**Petition for Post-Certification Modification
Tanager Battery Energy Storage System Project**

Data Response Set 4B

**Los Esteros Critical Energy Facility
03-AFC-02C**

DATA RESPONSE SET 4B

FIGURE DRA82-1
SITE MAP
 LOS ESTEROS TANAGER BESS PROJECT
 03-AFC-02C

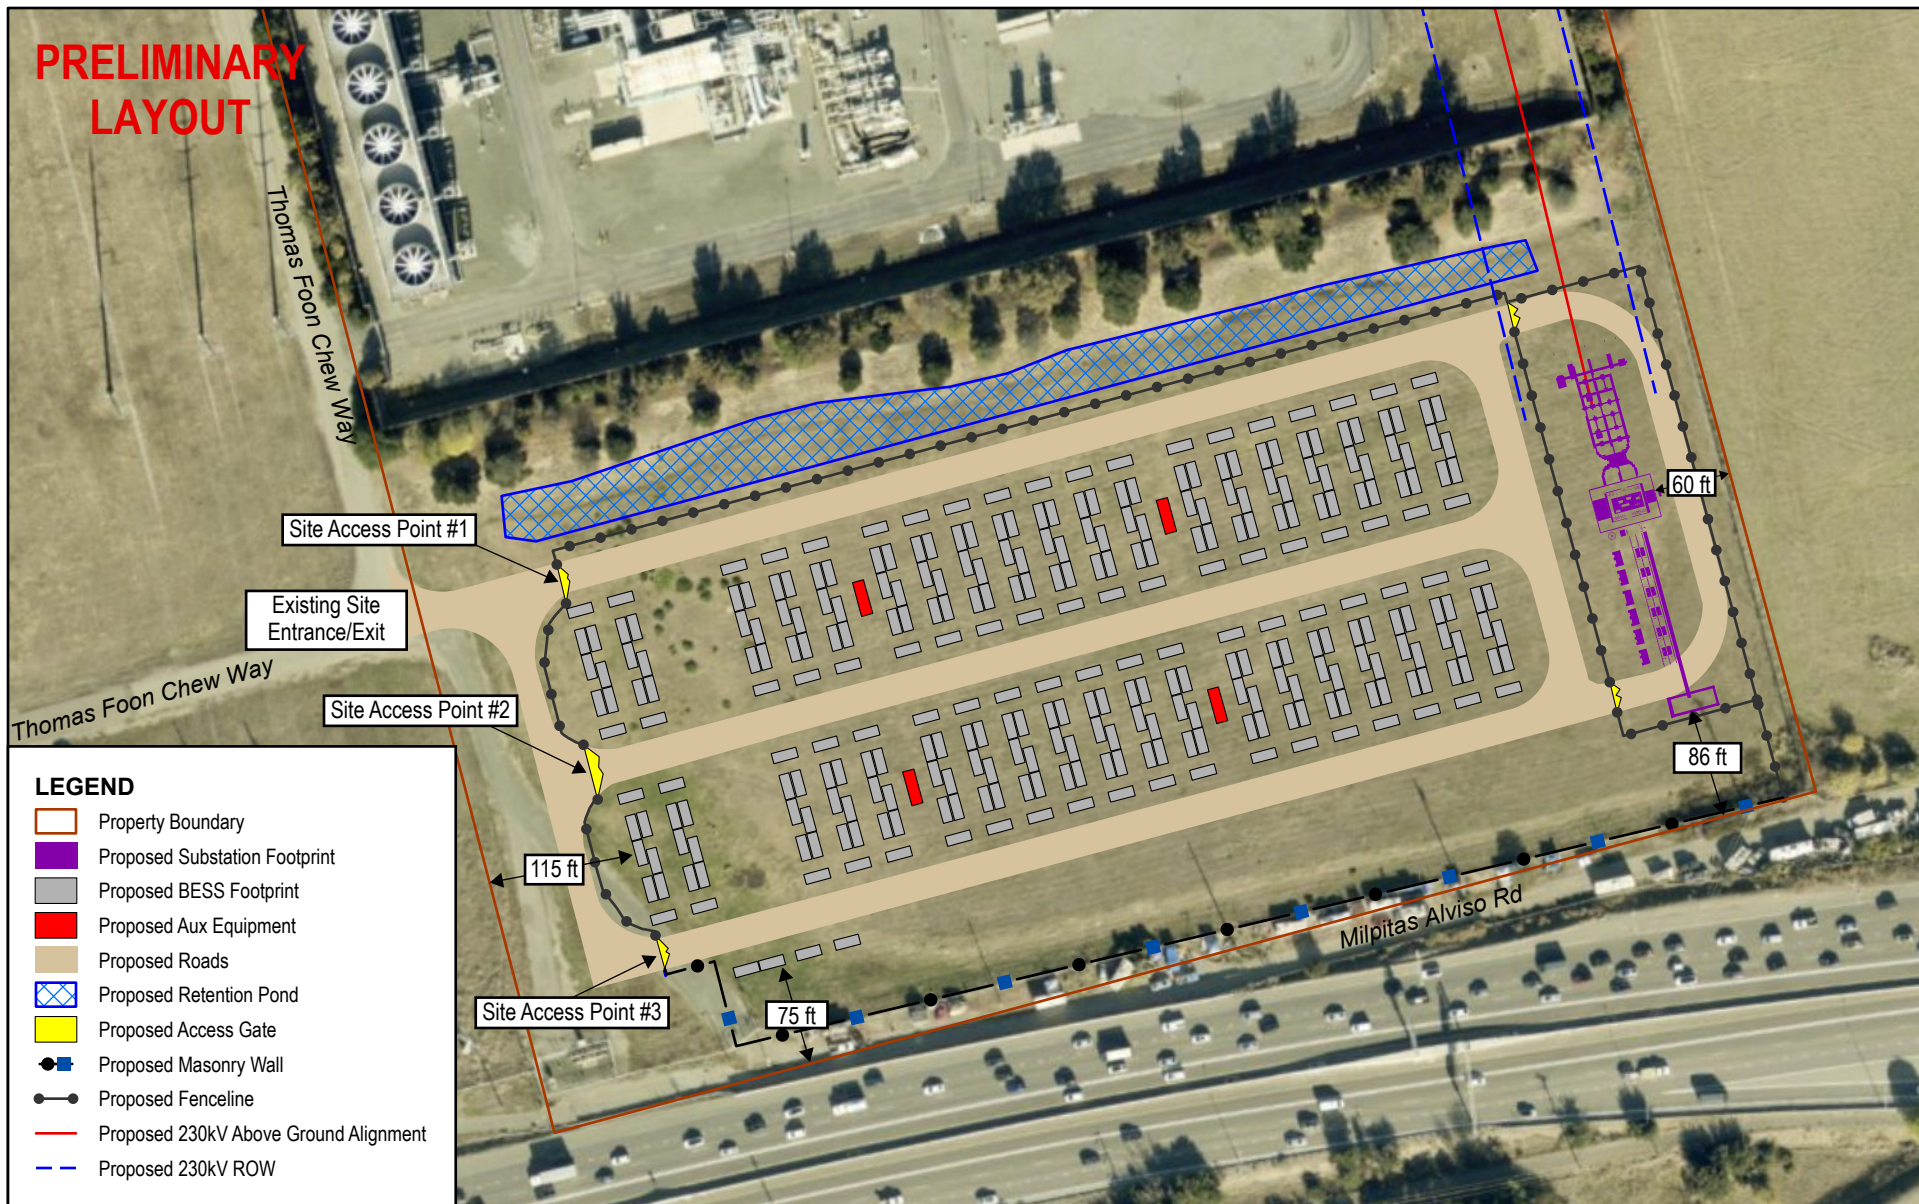
A82. *Provide a description and a revised plan view or new map on an in-focus aerial photo base showing the setbacks for the BESS site. Please show and label the project site boundary.*

A83. *Describe the type and height of the security wall or fence that would border the BESS facility, and please add it to the revised plan view or new map. (Also refer to the Visual Resources data request below regarding a perimeter wall.)*

A84. *Provide a map on an in-focus aerial photo base with existing and proposed site entrance and exit roads and the proposed internal road with these features labeled. Please show and label adjacent roadways that would connect to site entrances and exits. This map content can be added to the map requested above showing the project site boundary, setbacks, and the security wall or fence.*

A85. *Provide a revised plan view or new map on an in-focus aerial photo base showing the proposed gen-tie line in greater detail, including above-ground segments and the estimated disturbance area for construction. Please include parcel boundaries.*

RESPONSE: See Figures DRA82-1 and DRA82-2, which show the revised plan view over an in-focus aerial imagery base and depict the setbacks for the BESS site and project boundary.

RESPONSE: See Figures DRA82-1 and DRA82-2, which show the revised plan view and site boundaries over an in-focus aerial imagery base for the BESS site.

At this time, the project design includes a six foot noncombustible perimeter security barrier. The proposed perimeter security barrier will consist of a concrete masonry unit (CMU) wall along the southern project boundary and anon-scalable aluminum or similar fencing system along the remaining project perimeter.

RESPONSE: See Figures DRA82-1 and DRA82-2, which show the revised plan view over an in-focus aerial imagery base for the BESS site. These figures depict the existing and proposed site entrance and exit roads, proposed internal roads, and adjacent roadways that connect to site entrances and exits.

RESPONSE: See Figures DRA82-1 and DRA82-2, which show the revised plan view, including proposed gen-tie line, over an in-focus aerial imagery base for the BESS site. The proposed 230 kV gen-tie line extends approximately 0.3 miles and assumes an approximately 125-foot-wide gen-tie right-of-way (ROW) as the basis for estimating potential worst-case construction disturbance. Based on these assumptions, the estimated gen-tie corridor disturbance area is approximately 4.5 acres (0.3 mile $\times$ 125 feet wide), representing the gross ROW/survey area.

The gen-tie line is proposed along the eastern edge of the BESS site and extends north to connect to the Los Esteros Substation. A small portion of the gen-tie alignment will be installed underground, while the remaining segments will be above ground. Figures DRA82-1 and DRA82-2 provide additional detail regarding the gen-tie alignment, including labeling of the above-ground and below-ground segments. The parcel boundary is also labeled on both figures.

Item	Estimated Value for Tanager BESS Gen-Tie
Voltage	230 kV
Structure type	Steel monopole transmission structures
Gen-tie length	~0.3 miles (~1,500 feet)
Estimated number of overhead structures	Three poles, as shown in Fig DRA82-1, plus one H-frame in the substation footprint
Pole height	Approximately 110-120 feet
